# SQUARE 487

COMMISSION OF FINE ARTS | CONCEPT REVIEW | 20 MAY 2021

SECOND SUBMISSION | FIRST REVIEW: 18 MARCH 2021

ROCKEFELLER GROUP | STONEBRIDGE

# Revised Massing B

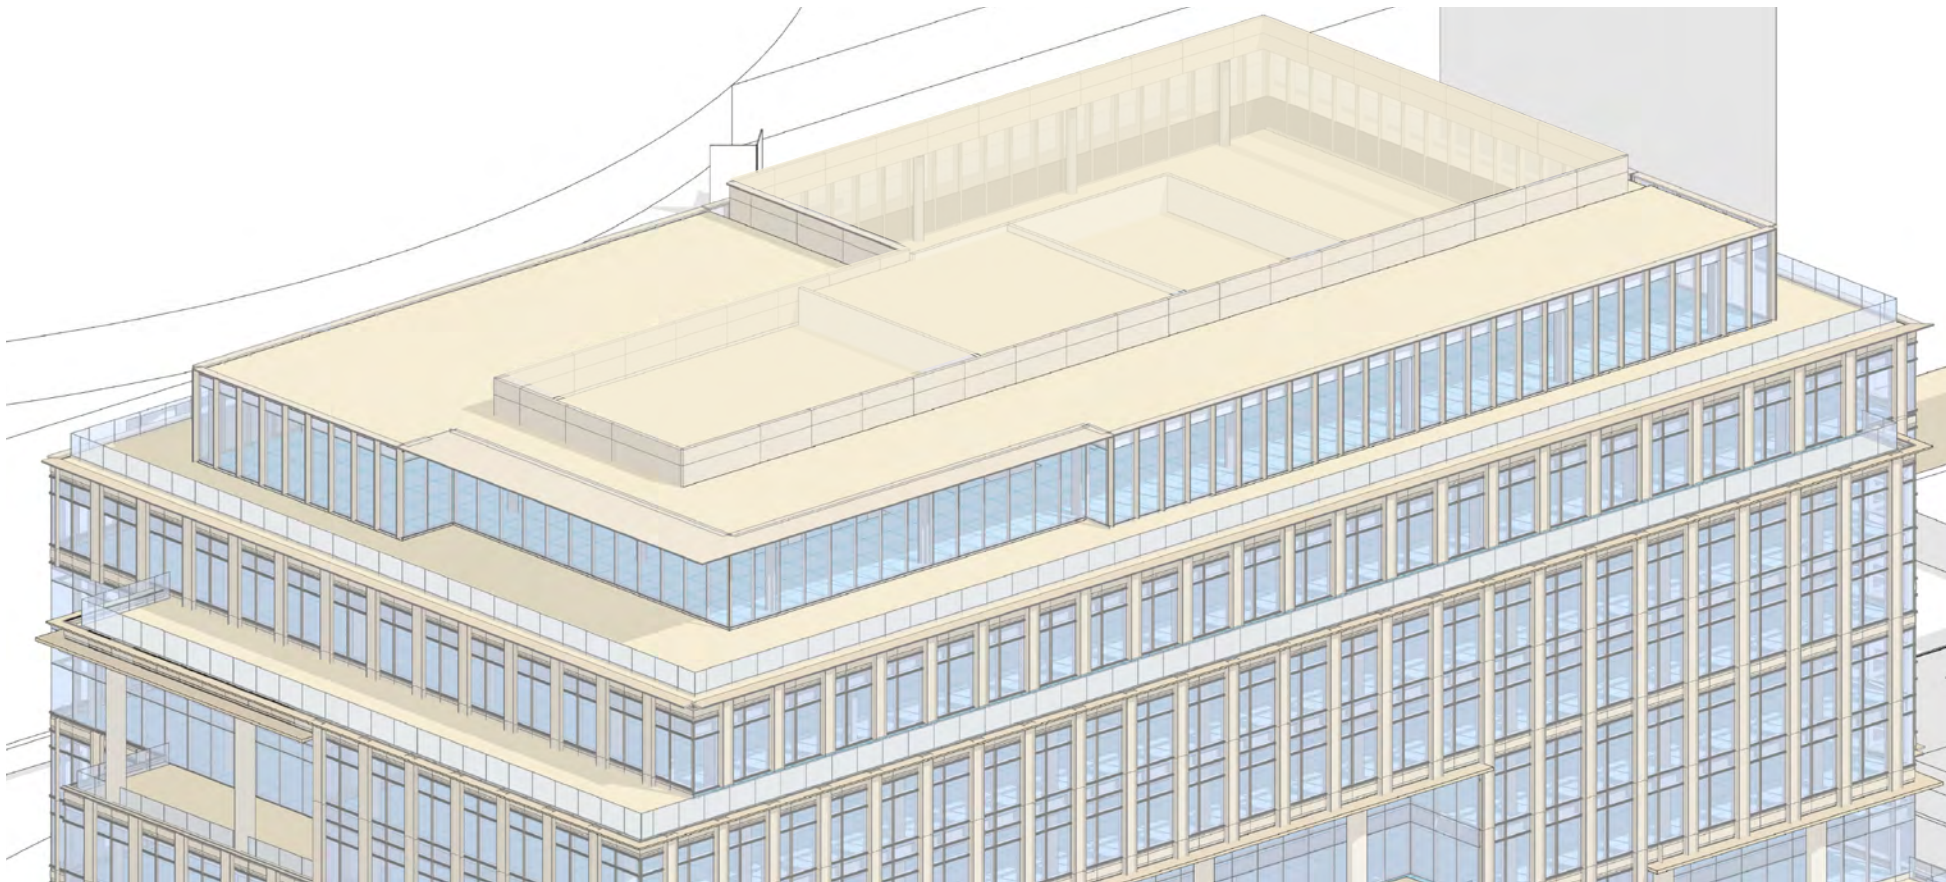
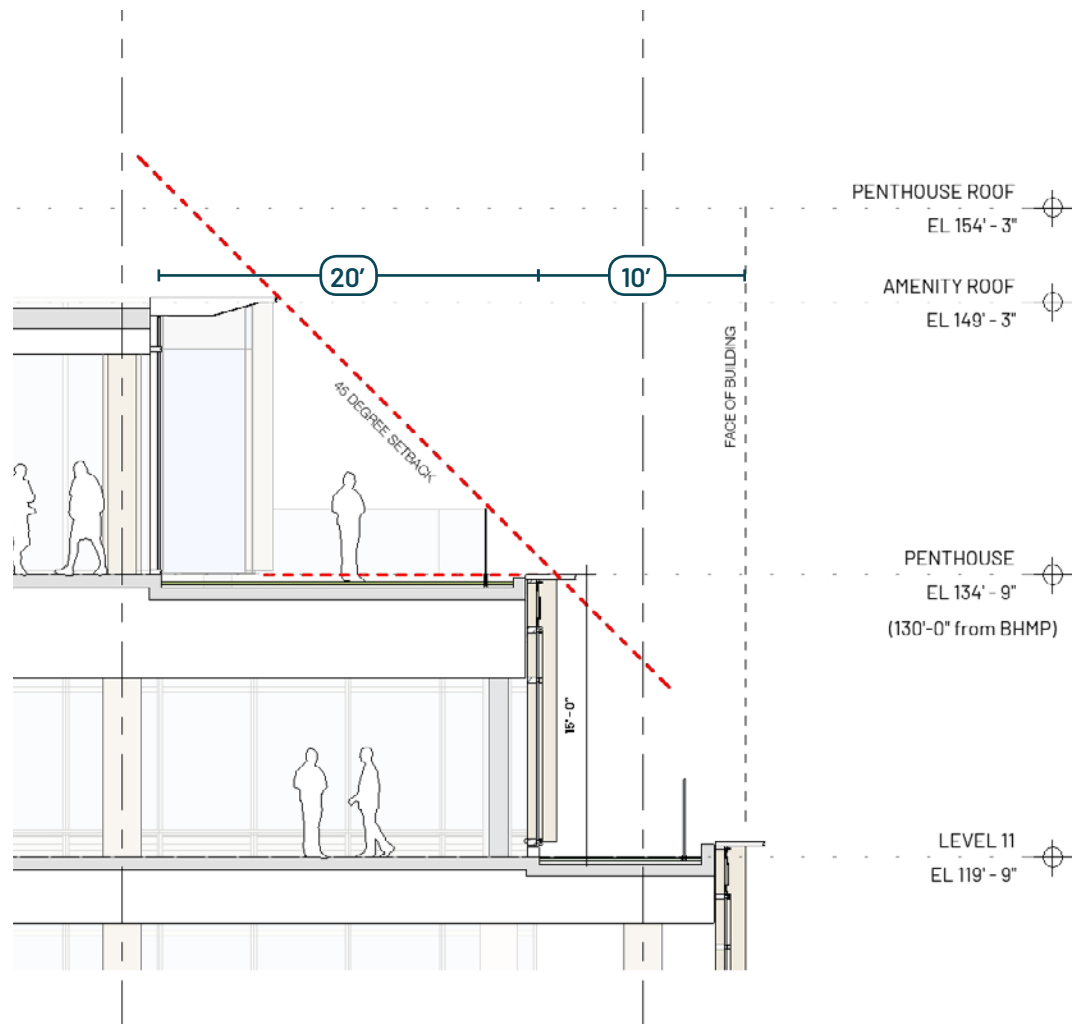
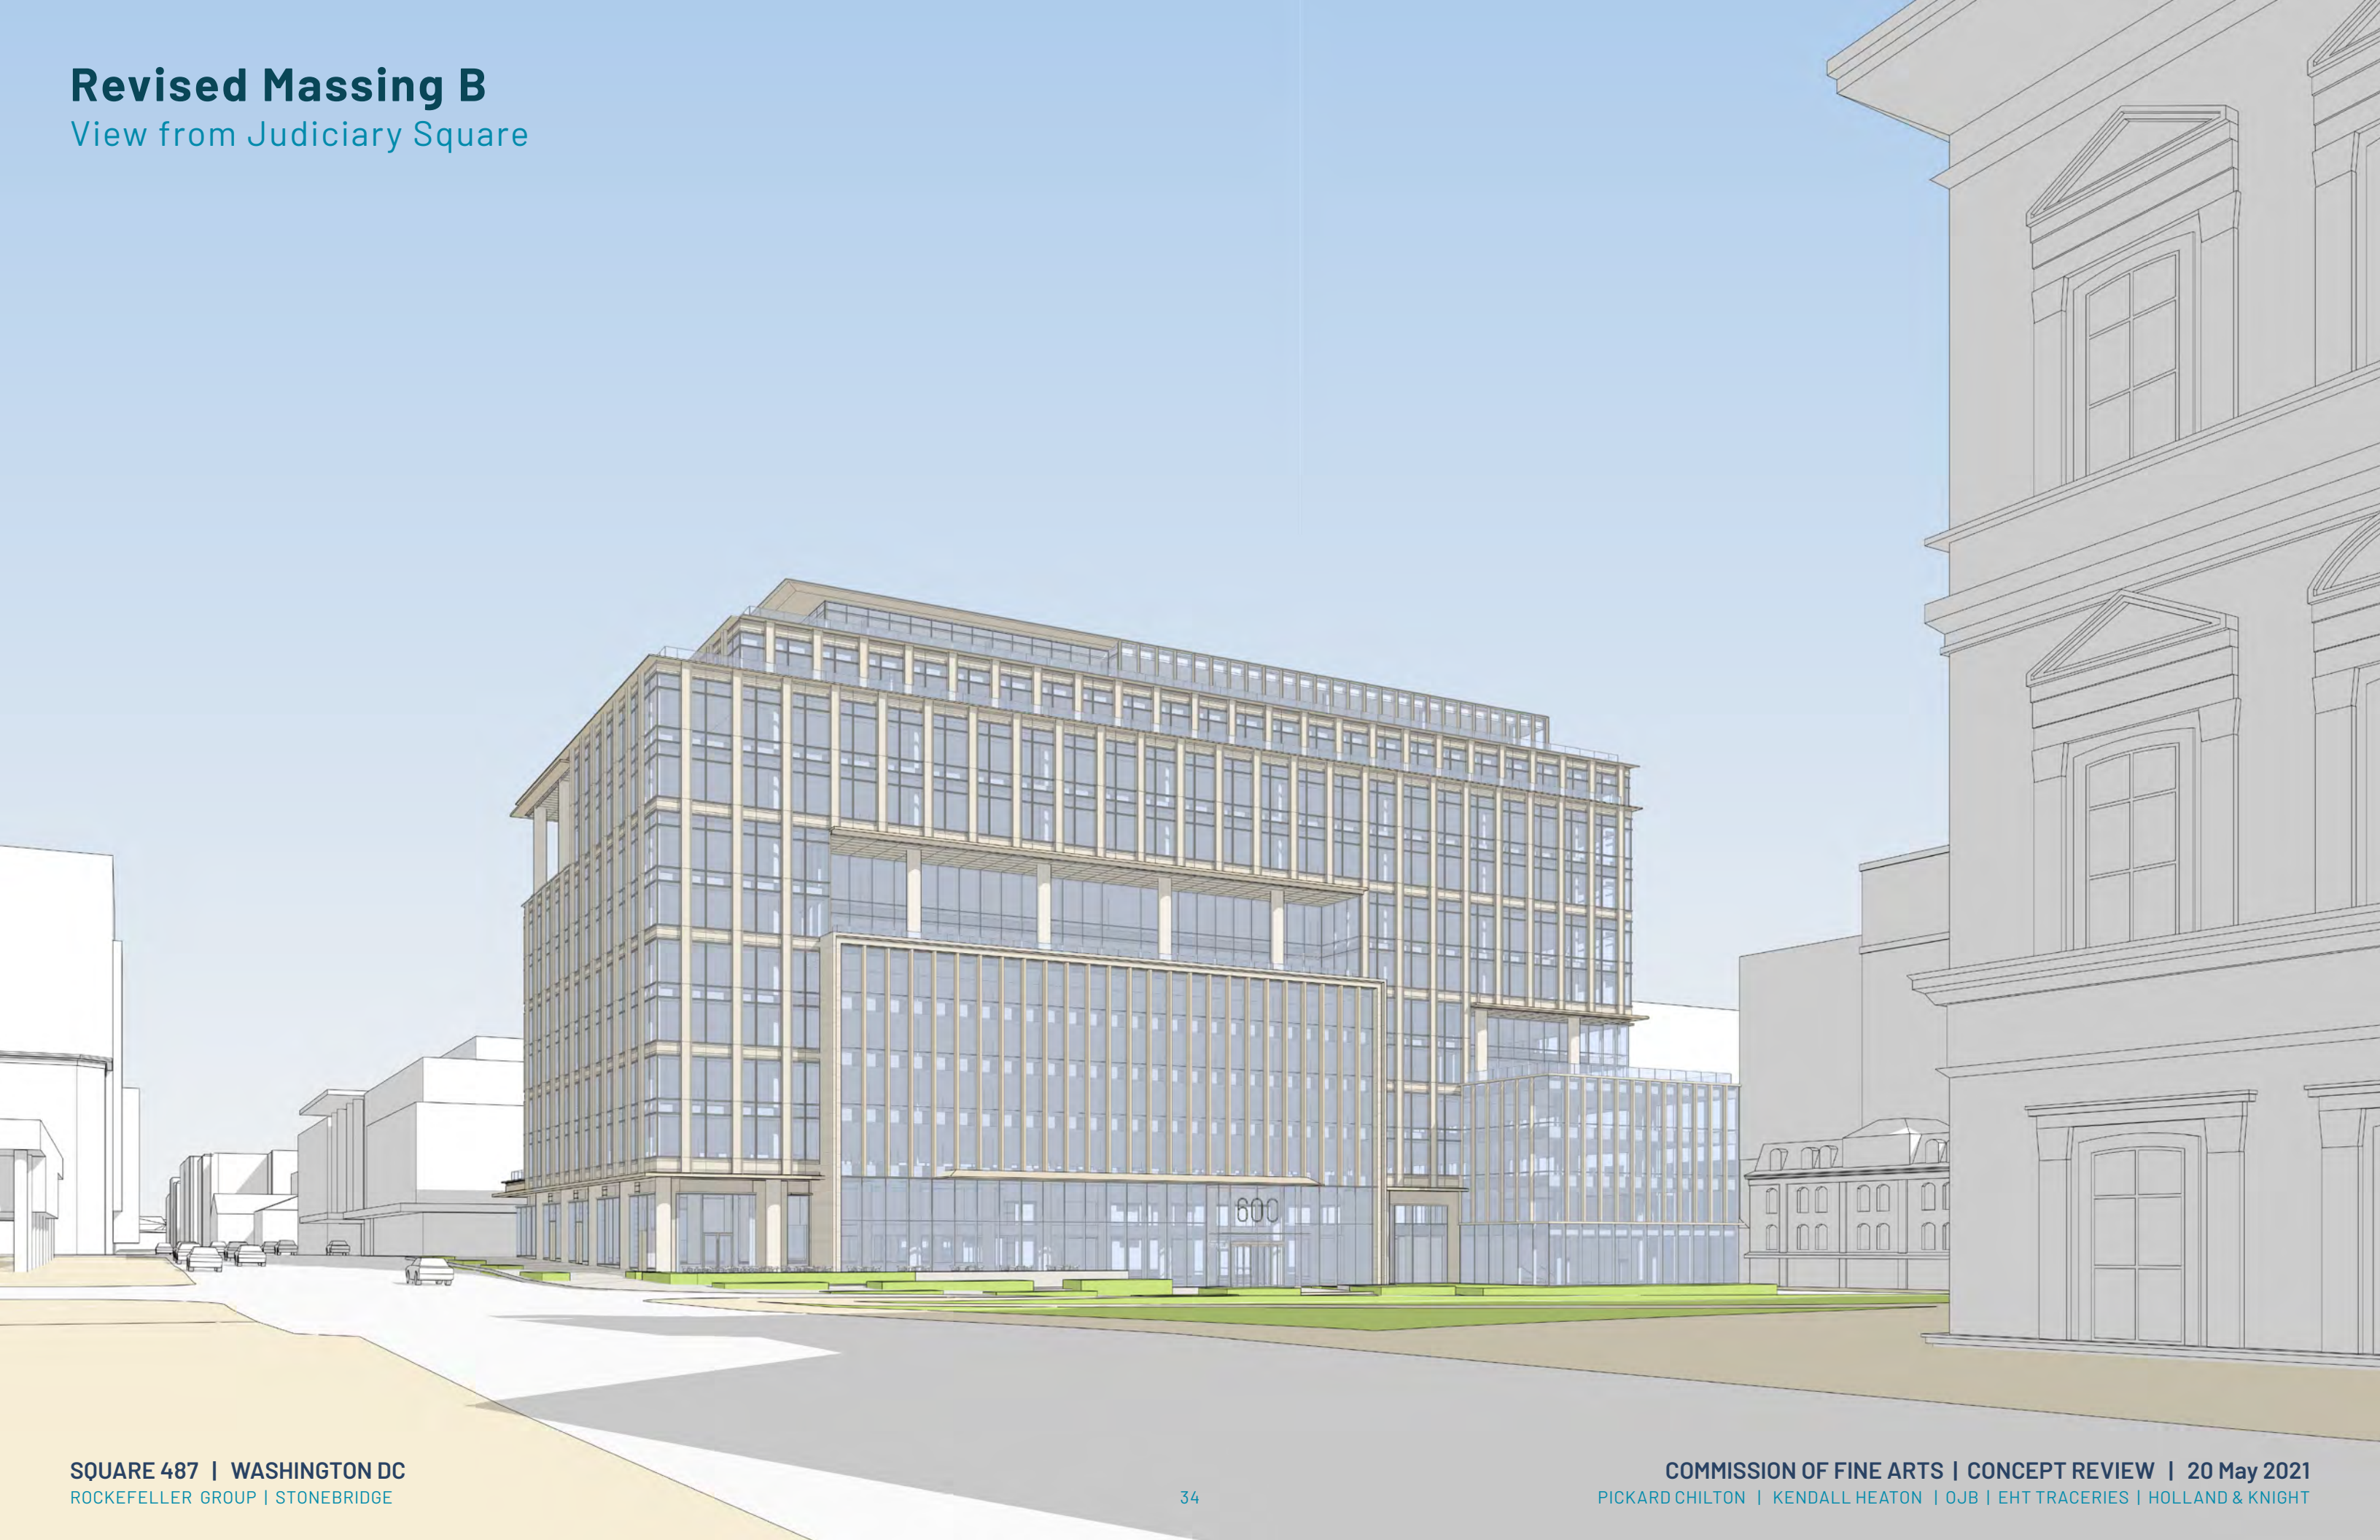
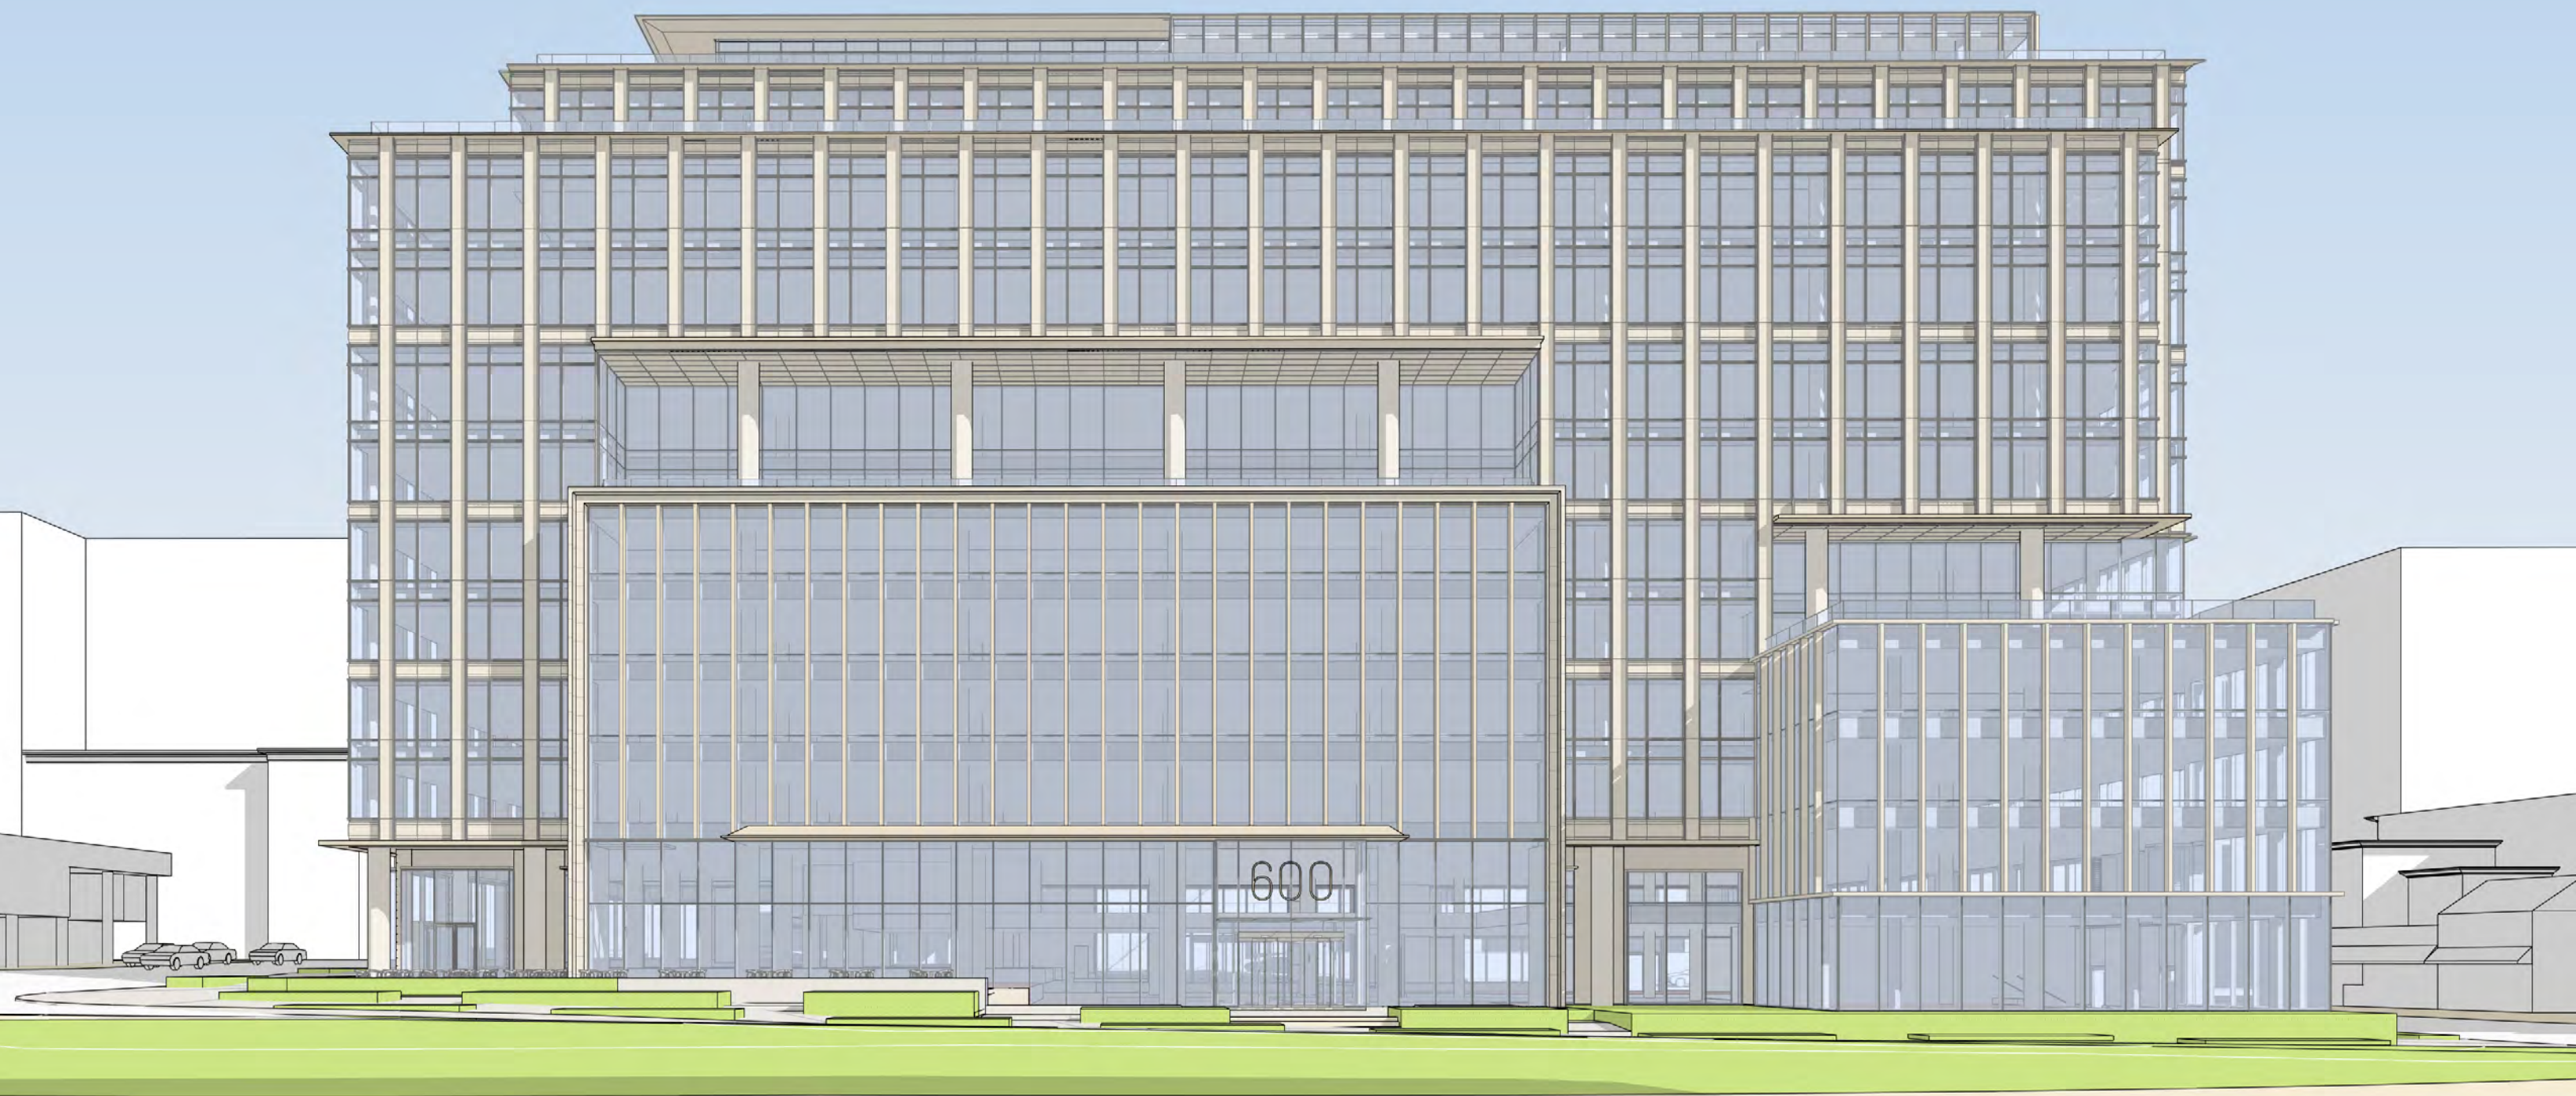
“...recommended further study of the top stories in order to minimize the impression of reflexive, incidental massing by reducing the number of step-backs and deliberately integrating the top into the overall composition of the building.”

**Penthouse** - Designed and developed options to reduce visual prominence, create shadow lines, and leverage system of brows and cornices to integrate with the overall building

# Column Articulation

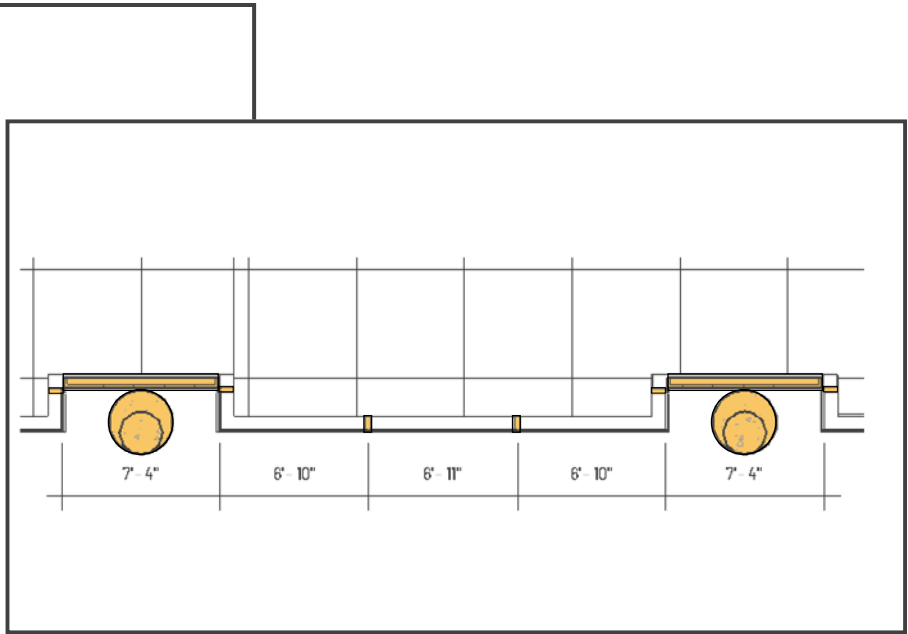
### CFA Comment:

*"...recommended adding limestone to the building's exterior, ... particularly at places of public contact, such as the exposed columns..."*

**Column** - Retained round column enclosure

# Facade Materials

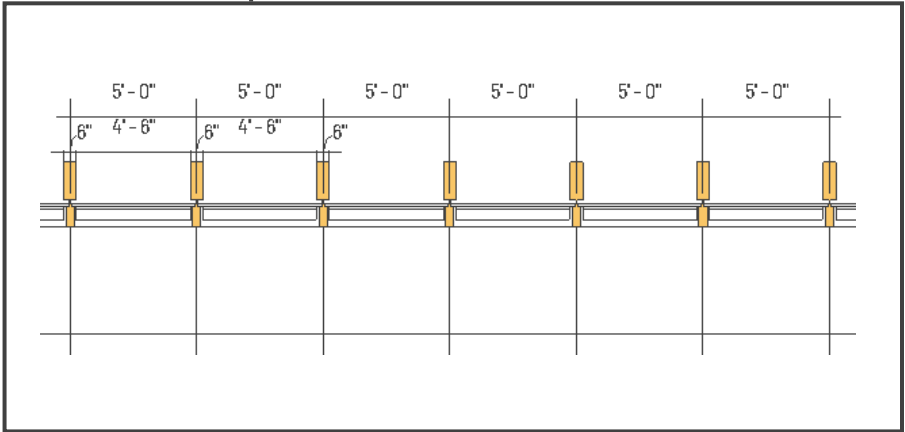
CFA Comment:

*"...recommended adding limestone to the building's exterior, possibly within the curtainwall system and particularly at places of public contact..."*

Masonry on Facade

**Materiality** - Increased scale & scope of limestone accent at Proscenium increased
